## **STAFF REPORT**

**TO:** Planning Commission  
**FROM:** Sophia Jensen, City Planner  
**AGENDA ITEM:** **Variance Request – 8286 Hidden Bay Court**

Jeff and Judy Otto (Applicants) submitted a variance application for three deviations from the City's Shoreland Management Overlay District Code Section 105.12.1260 Table 17-3. The three requests are: 1) an increase in impervious surface for unsewered shoreland lots 2) A reduced ordinary high water level setbacks for a new home 3) A reduced ordinary high water level setback for a new septic system. These requests are for the property located at 8286 Hidden Bay Court North (Subject Property).

**Figure B | Proposed New Septic Site Plan and Design**

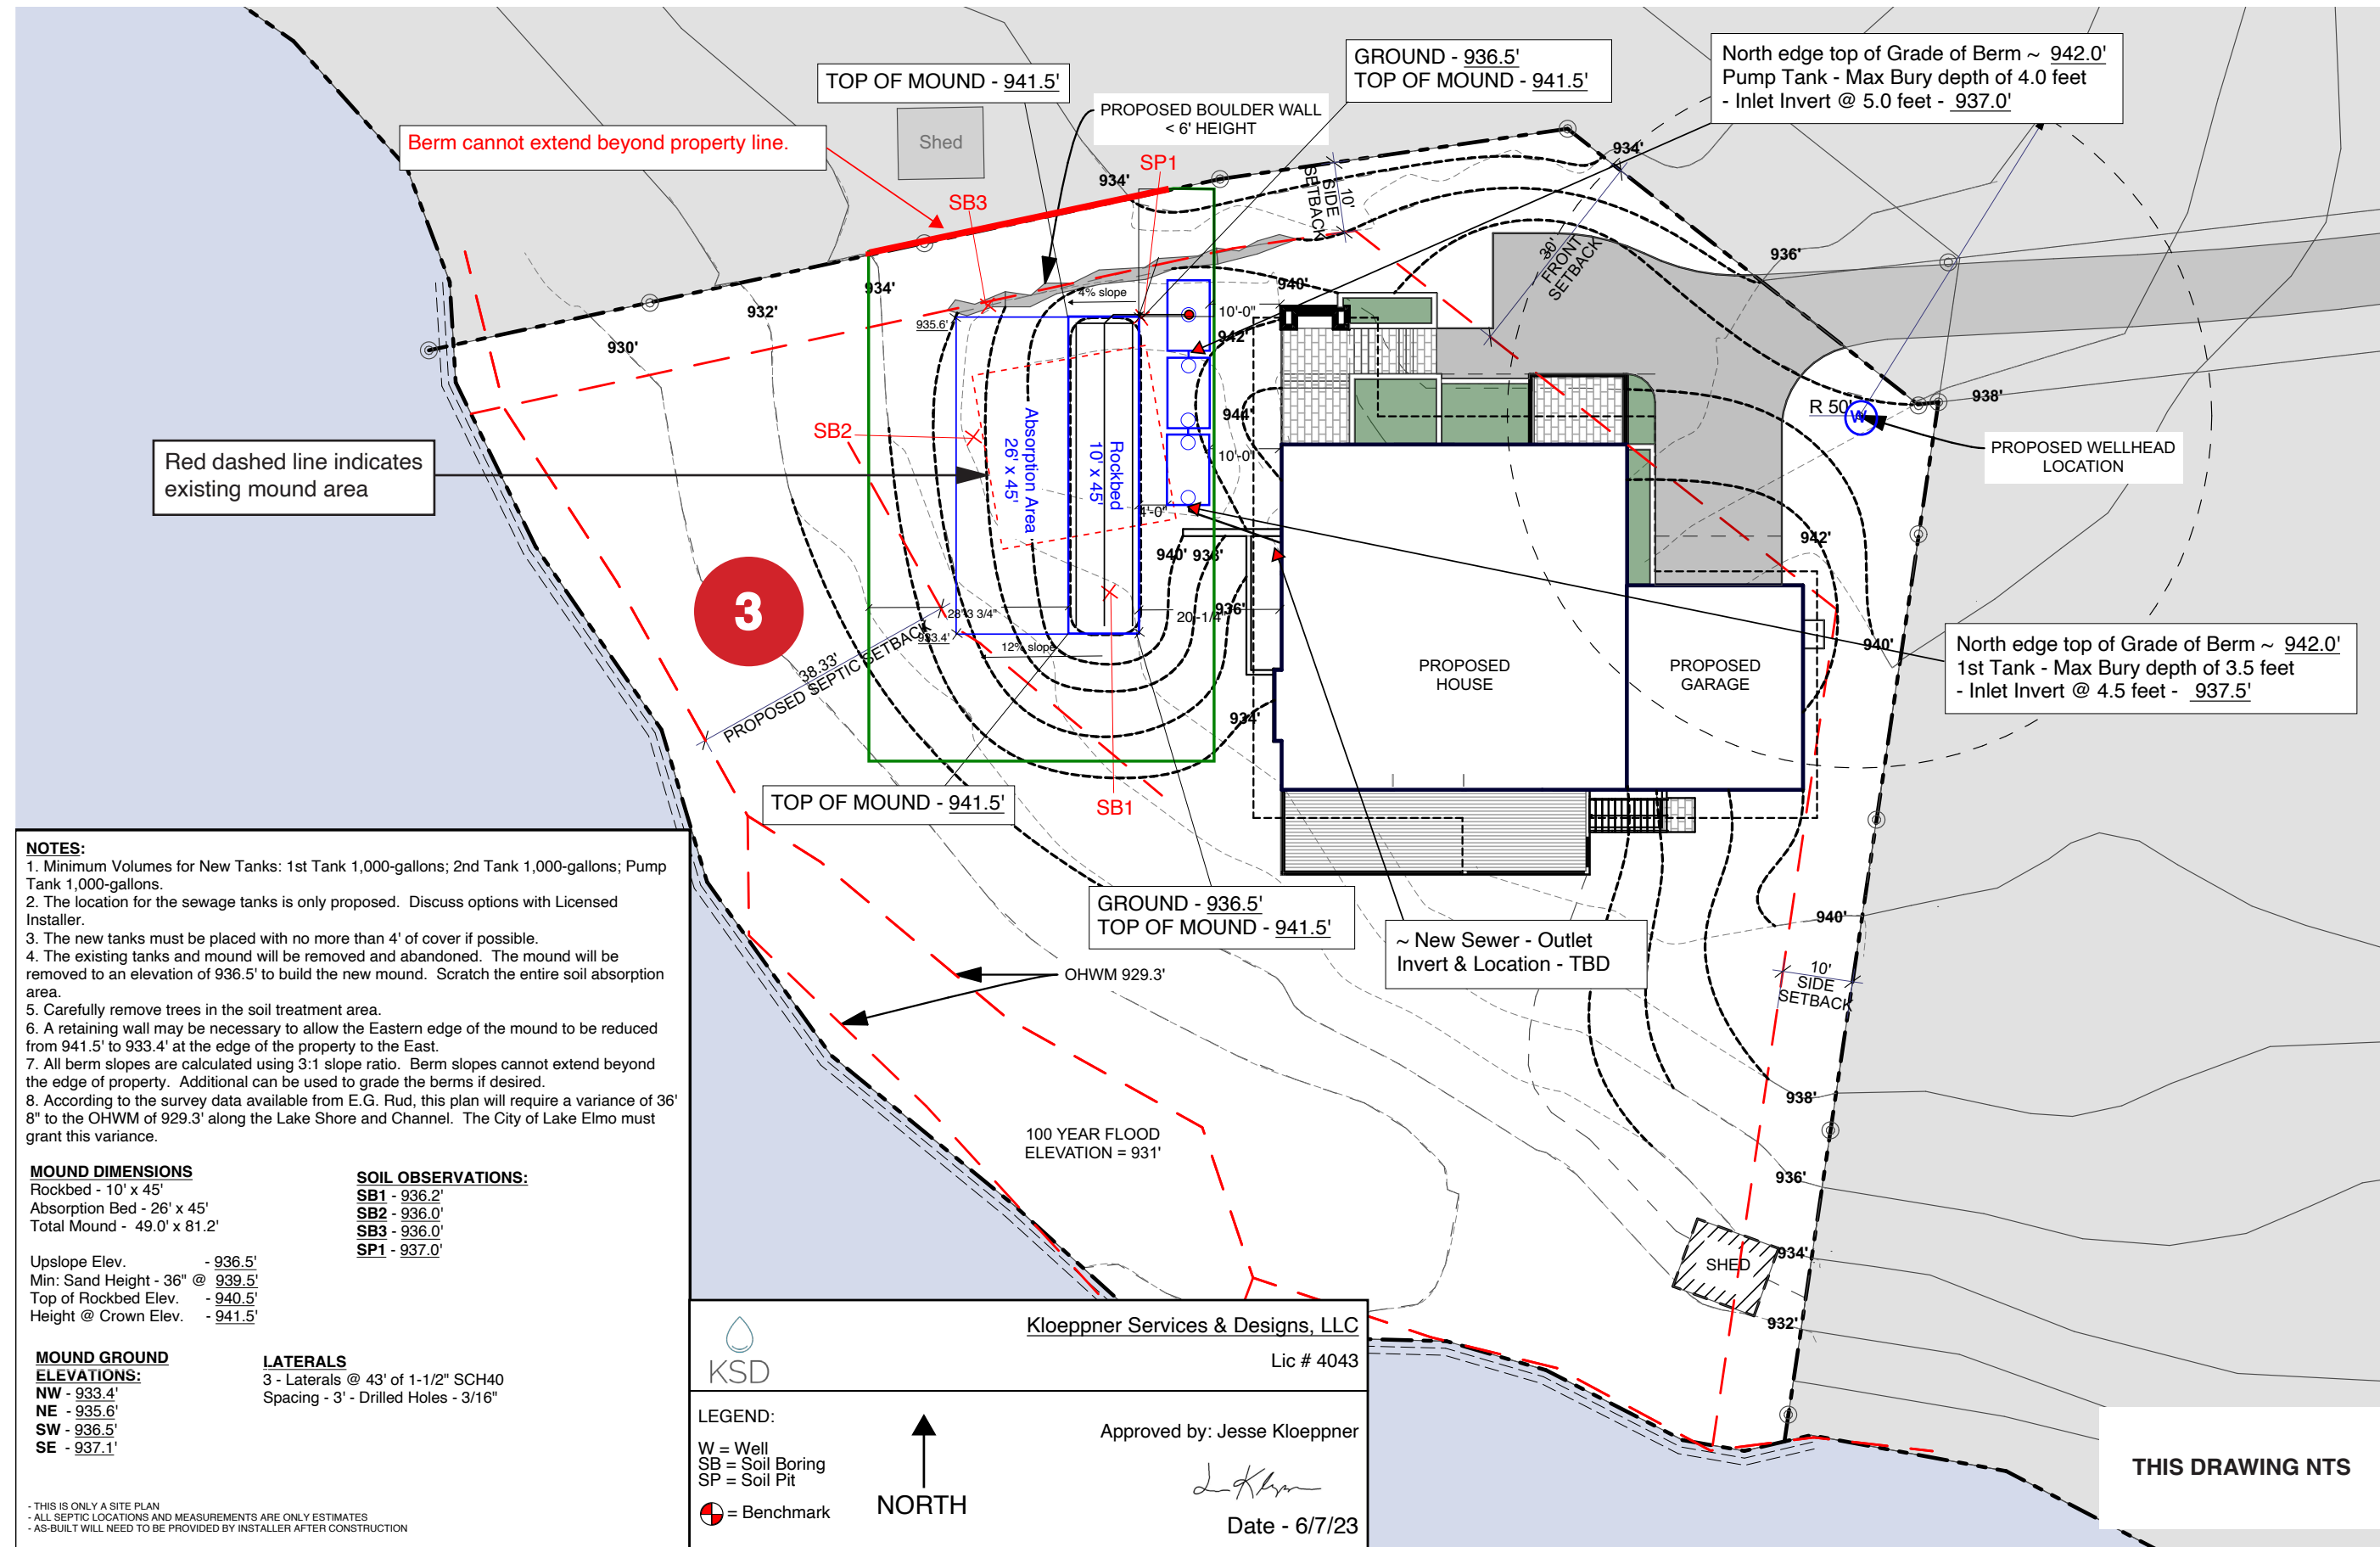
**REDUCED SEPTIC SETBACK FINDINGS:** The current system is failing and the applicant has had a septic designer review the property for a feasible septic location. Staff finds that the applicant has proven practical difficulties since a septic is needed given the current failing system and there is no other feasible area on site. **Practical Difficulties are met.**

**REDUCED SEPTIC SETBACK FINDINGS:** The applicant is proposing to replace the septic in roughly the same area of the property as the existing system. Again due to the fact this is a failing system, and the only location for a septic on the property **Unique Circumstances are met.**
